Department of Environmental Quality
Agency Headquarters
700 NE Multnomah Street, Suite 600
Portland, OR 97232
(503) 229-5696
FAX (503) 229-6124
TTY 711

May 26, 2022

Entek International LLC
250 Hansard Ave.
Lebanon, OR 97355
Sent via email only

DEQ received the submittal of the Cleaner Air Oregon (CAO) Modeling Protocol for ENTEK International LLC (Entek) in Lebanon, OR on February 17, 2022, as well as the Risk Assessment Work Plan (Work Plan) on March 18, 2022. Additionally, DEQ met with Entek to discuss these documents on April 19, 2022. DEQ has completed an initial review of these documents.

Figure 1: Aerial view of taxlots of the source and surrounding area.

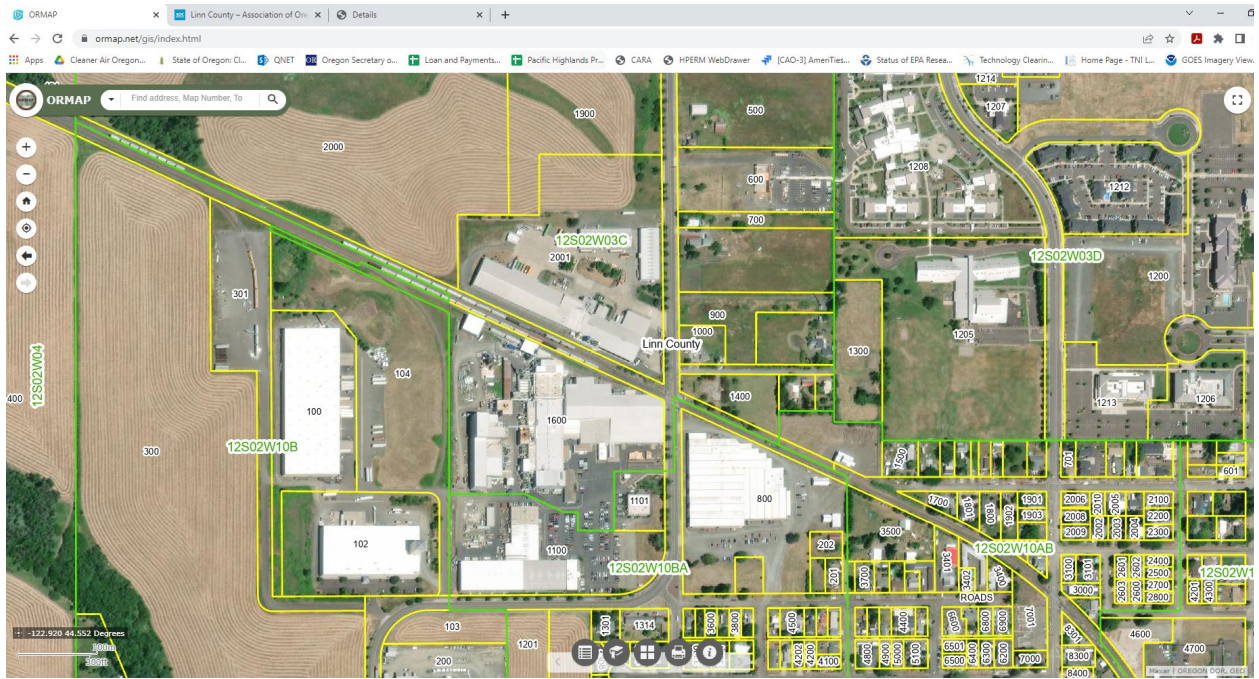
- i. Please provide information demonstrating that Taxlot 104 on Map Number 12S2W10B (see Attachment B, Figure 1), the land between the Entek manufacturing facility on Taxlot 1600 and the Entek warehouse located on Taxlot 100, is included on the lease of the warehouse from Western Warehousing LLC and should be considered as part of the Entek source; and

- ii. Please provide information demonstrating that the operations and emissions associated with the Entek Manufacturing Inc facility on Taxlot 1100 on Map Number 12S2W10BA (see Attachment B, Figure 1) are included in the current Title V Air Quality permit in order for this facility to be considered as part of the Entek source for the purposes of this Risk Assessment. It is our understanding that Entek Manufacturing is not included in the Entek International TV permit.

- b. Regarding the property on Taxlot 1400 on Map Number 12S2W03C (see Attachment B, Figure 1):
 - i. Please provide documentation that Entek will restrict public access to this area by installing both physical (e.g., fencing) and administrative (e.g., signage) controls; and

- ii. Because exposure locations in the CAO program are assessed based on the underlying zoning, which in this case is Exclusive Farm Use, please request an exposure location change using [AQ521](#) & [522](#) forms for modeling receptors on this taxlot consistent with its use.

Figure 2: Aerial view of proposed exposure locations around the facility.

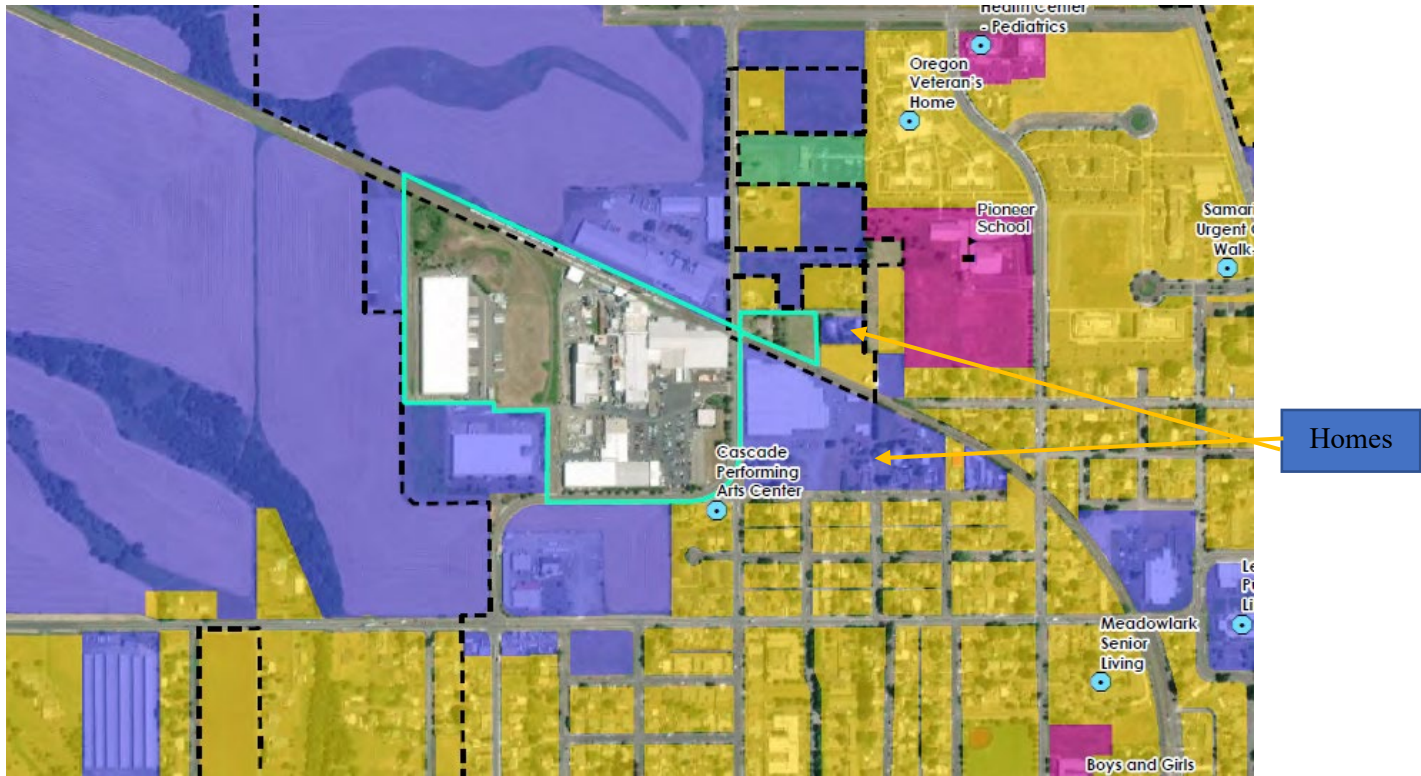
- c. In Figure 4-9, there are homes labelled as ‘Worker’ exposure locations directly east of the facility (see Attachment B, Figure 2) – please update these to ‘Residential’ exposure locations.
